SERVICE BULLETIN

L1021 2025-11-20

L1021: TECH TIP 001 - S2 DEL MAR AC FILTER RUNNING CHANGE

Figure 1. Old AC Filter P/N 66000371

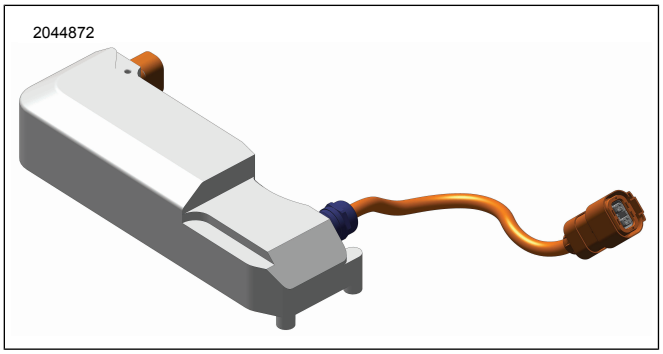
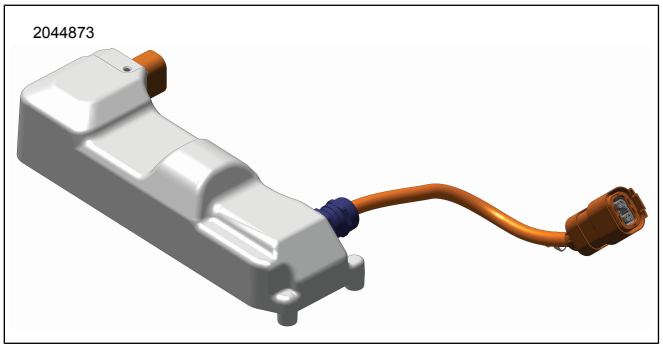
This bulletin informs dealers and technicians of a running change to the Alternating Current (AC) Filter on the 2024 S2 Del Mar (S2DM). Vehicles built prior to November 13, 2023 have a filter (Part No. 66000371) which has been superseded to (Part No. 66000371A).

Replacing AC Filter (Part No. 66000371) will require additional parts and fasteners to install the superseded AC Filter (Part No. 66000371A).

Inspect AC Filter assembly to determine if vehicle is equipped with old part number. If vehicle is equipped with the old part number, order the additional parts to retrofit to superseded design.

- QTY 1 - Bracket (Part No. 12700197)
- QTY 2 - Screw (Part No. 10200795) (fasten bracket to filter)
- QTY 3 - Screw (Part No. 10201293) (fasten filter to skid plate)
